PULTE 2 DEGREES

11762 AURORA AVE N | SEATTLE, WA 98133

EARLY DESIGN GUIDANCE 2 | SDCI #3036031-EG | 12 JULY 2021 (MEETING DATE)

1A+B, 2A+B - Site plan iterations

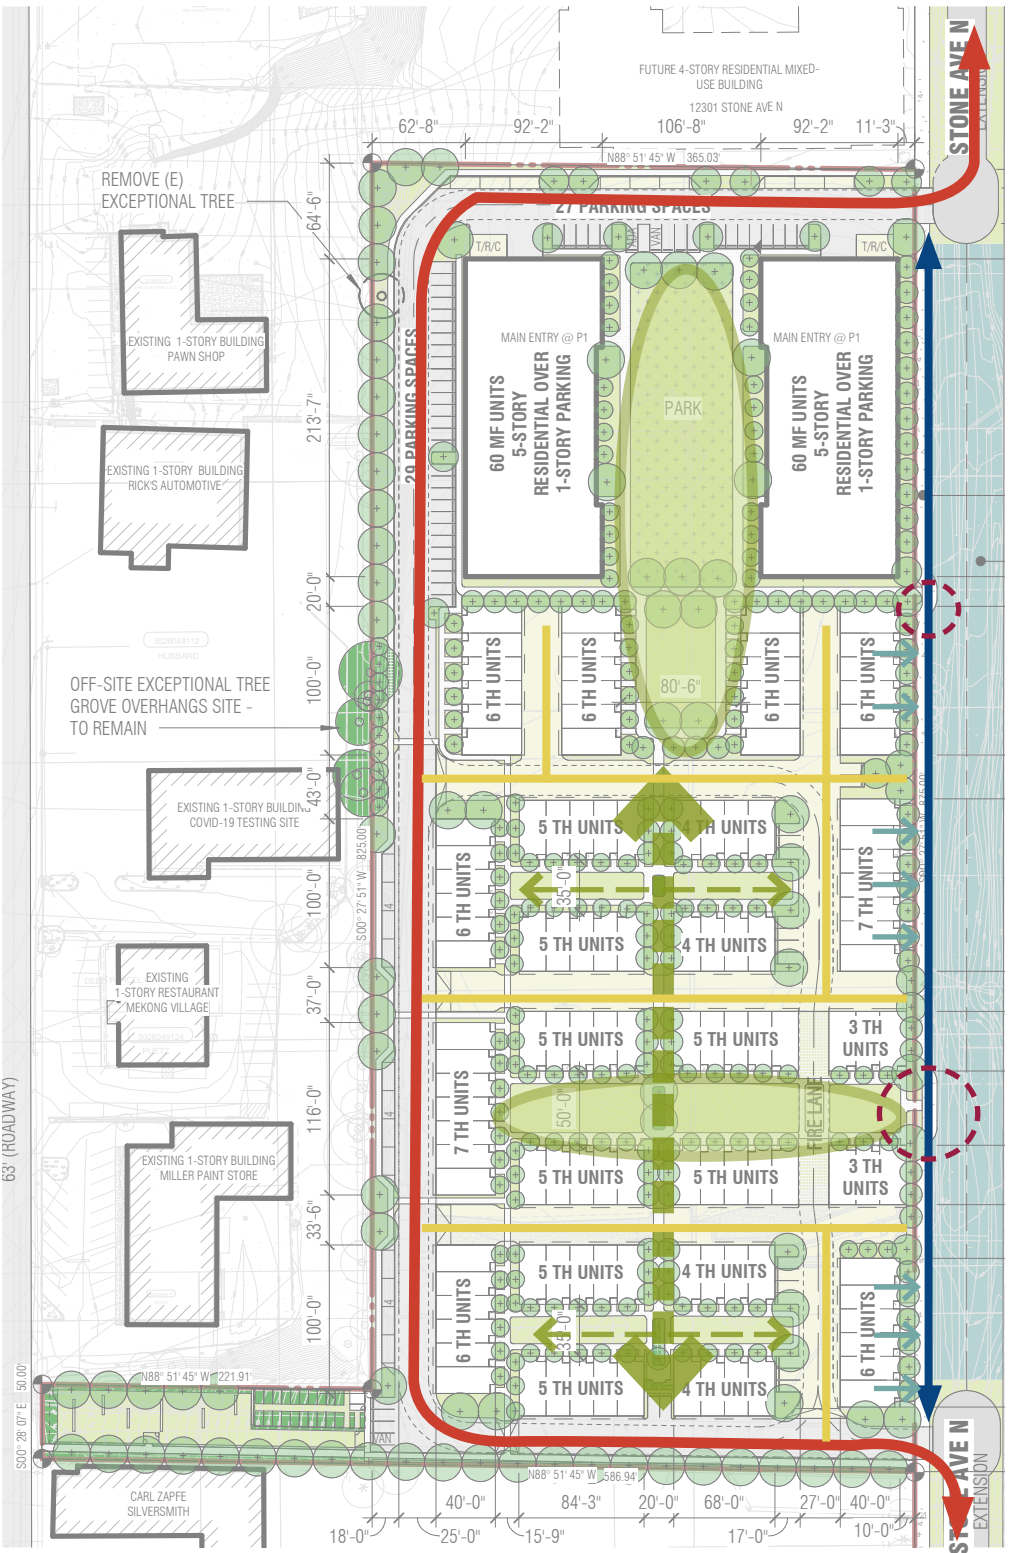
- a. The Board noted the large size of the site and expressed concern regarding the limited degree of exploration provided in the packet, particularly around site planning, pedestrian circulation, architectural form and open space planning. The Board recommended the project return for a second Early Design Guidance meeting to present additional options to address those issues. (CS3, PL2, DC2, DC3)
- b. The Board did not recommend any of the proposed schemes move forward to MUP application but recognized positive aspects in EDG1 Option 3 (refer to page 28) that could be a base for further development, including the creation of a network of pedestrian and shared open spaces and the orientation of townhouse units toward the non-motorized path along the Stone Avenue North SPU detention facility. (CS1, DC1)

Additional site studies were done based on Option 3 from EDG1 as the basis for further development. These studies collectively explored site planning, pedestrian circulation, architectural form, and open space planning to arrive at two site plans, OPTION 1 “Commons” and OPTION 2 “Promenade”, both of which address the board’s concerns and create a more hierarchical and inviting community. Both options include a comprehensive and robust pedestrian network integrated among the abundance of shared open spaces located throughout the site. These open spaces and pedestrian network also directly relate with the non-motorized path along Stone Avenue North

2D Open and safe trail

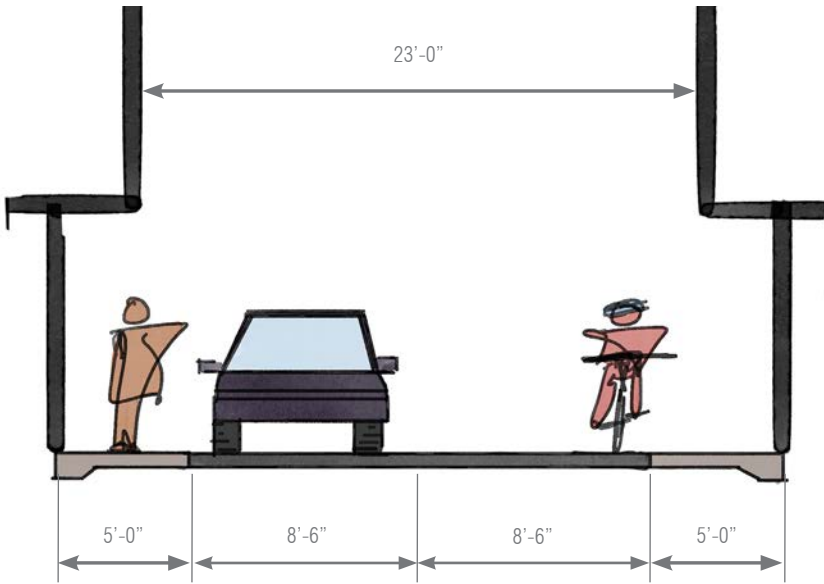
- d. Stone Avenue North: Echoing public comment, the Board noted the importance of this north-south route to the larger neighborhood and agreed that the design of the non-motorized trail and townhouses should help create an open, engaging and vibrant area that encourages human interaction and provides safety and security. (PL2-B, PL3)

2D RESPONSE:

The proposed Stone Ave N non-motorized path will be 10’ wide and connect the northern and southern Stone Ave N cul-de-sacs. This off-site path will be thoughtfully designed to be inviting and safe, pending SPU approval. Both proposed options orient the townhouse units along the eastern property line towards the east, facing the SPU detention facility. This configuration will encourage human interaction, provide eyes on the ‘street,’ and promotes safety and security.

2E Example of use of special paving, garage access and plant zones

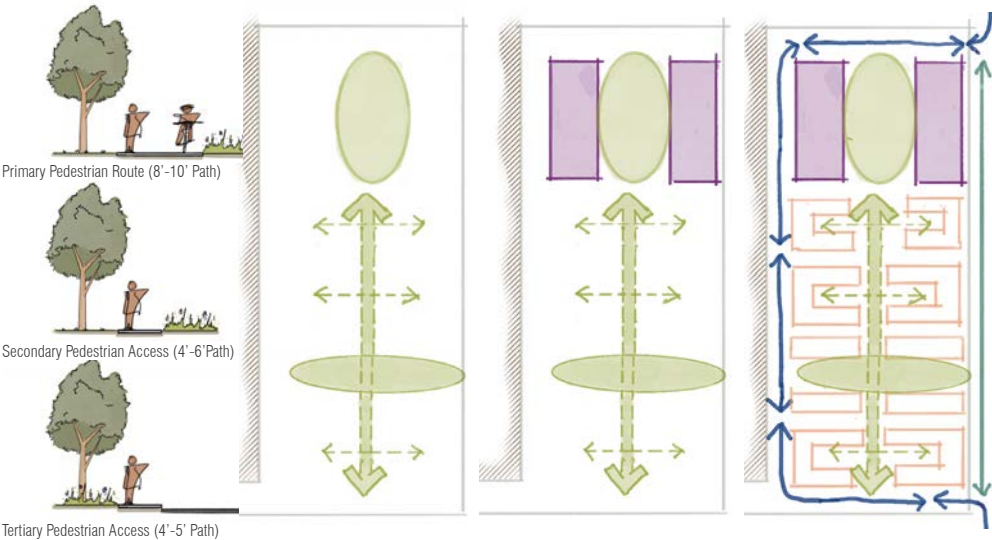
- e. The Board supported the intention to design interior circulation areas for shared pedestrians and vehicles use in the manner of a “woonerf” (a Dutch word meaning “street park” and specifically, a street where pedestrians and cyclists have priority over motorists) and requested inclusion of details and a more complete explanation for the next meeting. See page 26-27 for woonerf details. (PL3, PL4, DC3)

2E RESPONSE:

Both revised options retain the woonerf concept proposed in the preferred EDG 1 (Option 3). All internal vehicular driveways act as woonerfs and provide additional pedestrian connections among the open spaces provided throughout the site and to Stone Ave N. Additionally, the width of the woonerfs have been increased by two feet (27’ total) to allow for a resident entourage zone to promote impromptu uses. Traffic calming strategies are also provided to enhance pedestrian security, such as bulb-out curbs, raised crosswalks (where necessary), and pedestrian-scaled paving patterns. See page 50-51 for woonerf details

3A+B - Pedestrian path and open space hierarchy

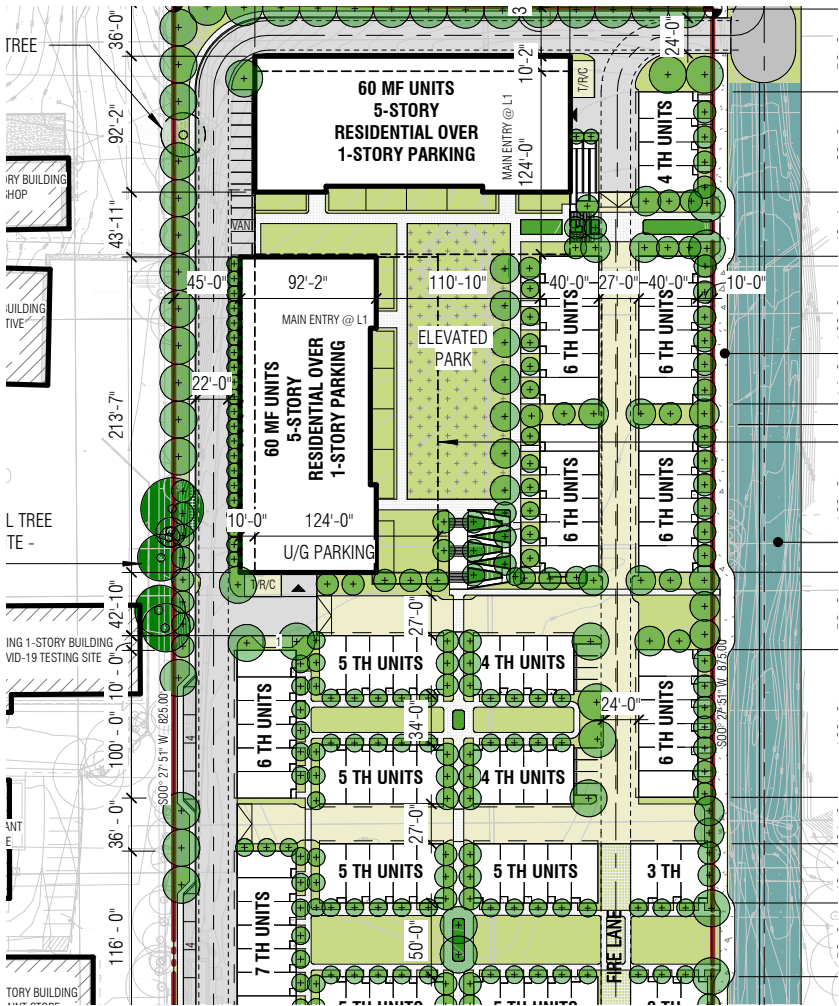
- a. The Board supported the intention to create a network of pedestrian paths and open spaces but agreed that the uniform regularity of arrangement had limited the viability of this system. The Board provided guidance to develop this network with a greater degree of variety in the size, shape and location of those open spaces and organize them with legible hierarchy to facilitate wayfinding, provide opportunities for interaction among residents and neighbors, and help create a sense of place on this unique site. At the next EDG meeting, the applicant should provide a conceptual open space plan addressing these issues and the items described below. (CS2-A, CS3-B, PL1, PL2, PL3, DC1, DC3)

- b. The Board provided guidance to explore the creation of a larger central open space in the heart of the site as part of a strategy to provide wayfinding, placemaking and foster opportunities for human interaction as called for in the guidelines. (CS2-A, CS3-B, PL1, PL2, PL3, DC1, DC3)

3A+3B RESPONSE:

Both proposed options provide vigorous opportunities for interaction among residents and neighbors by way of large open spaces and a robust pedestrian network that provides logical movement throughout the development. All residents have direct access to a large centralized open space, and all open spaces are interconnected by way of a hierarchal internal pedestrian network. Made possible by locating the main vehicular path along the perimeter of the site which de-emphasize the vehicle and encourages other modes of transportation/movement within the development and increase opportunities for neighboring and pedestrian interaction.

The pedestrian network contains paths that vary in width throughout the site, dependent upon their function. The path width directly correlates to the level of anticipated use. The wider the path, the heavier the expected traffic. The pedestrian path hierarchy is designed to foster wayfinding and reflect the open space hierarchy which follows a similar philosophy.

3A+C - Option 2 "Promenade" covered parking creates large elevated central open space

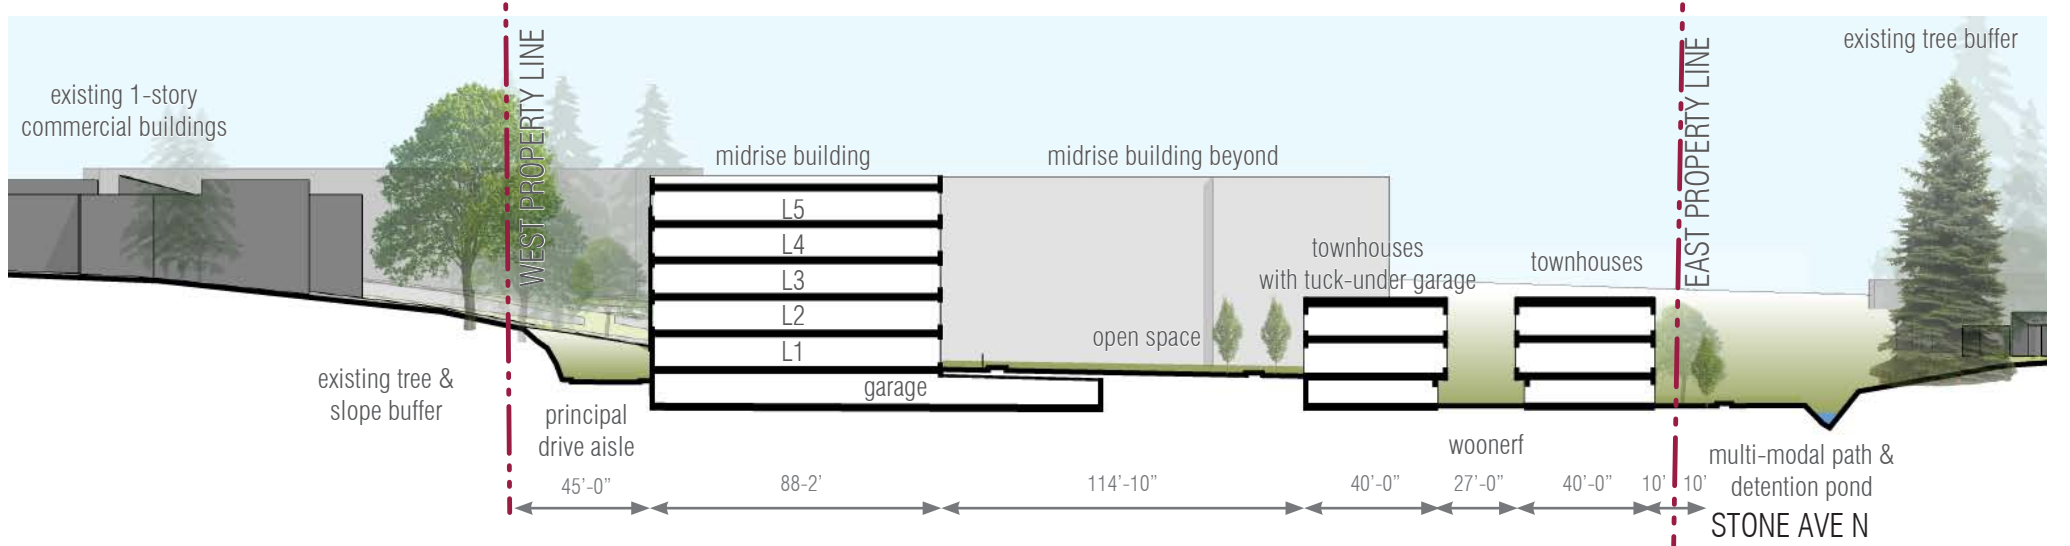
- c. The Board recognized that the uniformity in the pattern of site development was tied to the limited amount of open space remaining after meeting the applicant's development goals. The Board provided guidance to explore the creation of more open space by relocating surface parking below grade, noting that the greater latitude this would provide could help the project better respond to the guidance provided above. (DC3)

3C RESPONSE:

Both revised options push the principal drive aisle to the perimeter of the site. Additionally, Option 1 "Commons" also relocates the surface parking to the north and west property lines, eliminating any internal underutilized open space which increases the size of the central open space. This option reduces the prominence of on-site surface parking.
